UNITED STATES  
NUCLEAR REGULATORY COMMISSION  
WASHINGTON, D.C. 20555-0001

SUBJECT: OCONEE NUCLEAR STATION, UNITS 1, 2, AND 3 - FINAL  
RESPONSE TO TASK INTERFACE AGREEMENT 2014-05, DESIGN  
ANALYSIS FOR SINGLE FAILURE AND THE INTEGRATION OF  
CLASS 1E DIRECT CURRENT CONTROL CABLING IN RACEWAYS  
WITH HIGH ENERGY POWER CABLING (EPID L-2014-LRA-001)

FINAL RESPONSE TO TASK INTERFACE AGREEMENT 2014-05,

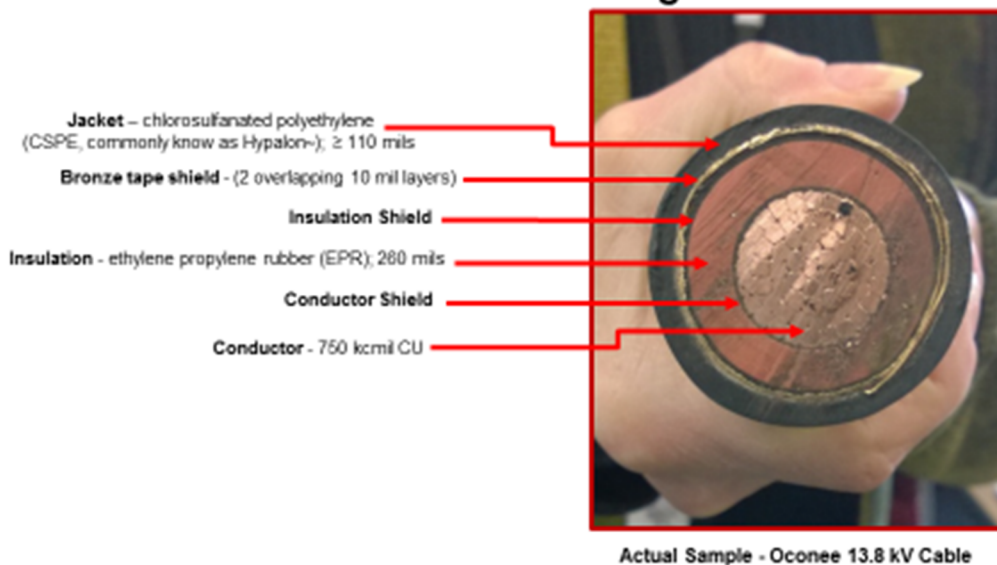
TIA Question 2.i

Can cable shielding or armor prevent short circuits or limit faulted currents and voltages?

- Can the two wraps of bronze shielding tape in the licensee's current power cable configuration be considered equivalent to the steel interlocked armored cable as described in the test report MCM-1354.00-0029.001?
- Are the results of test report MCM-1354.00-0029.001 sufficient to demonstrate that electrical faults cannot propagate from one cable to another as described in the single failure DBD, Section 3.3.6.1?

Response to TIA Question 2.i

No. The cables in trench 3 between the KHS and transformer CT-4 at ONS and the PSW ductbank between CT-4 and the PSW building, as a result of the plant modification, were not appropriately separated or capable of addressing short circuits or limit faulted currents and voltages as required by IEEE Std. 279-1968 and the single failure requirements of IEEE Std. 279-1971 and the ONS licensing basis as discussed in UFSAR sections. These cables' two wraps of bronze shielding tape cannot be credited for preventing short circuits or limiting fault currents and voltages. Cable shielding and cable armor serve different functions. Although the ONS licensing basis credits armored cable for mechanical and fire protection aspects of cable separation, the use of cable shielding is not an equivalent. A shield is employed in the subject cable design to preclude excessive voltage stress on voids between the conductor and insulation, and to confine the electric field of the cable to the insulation of the conductor or conductors. Based on the lack of a technical justification for the use of the cables in trench 3 between the KHS and transformer CT-4 and the PSW ductbank between CT-4 and the PSW building, the absence of a provision for this in the ONS licensing basis, or an NRC accepted industry standard to that effect, the cable shielding or armor used in trench 3 and PSW ductbank are not demonstrated to prevent short circuits or limit faulted currents and voltages.
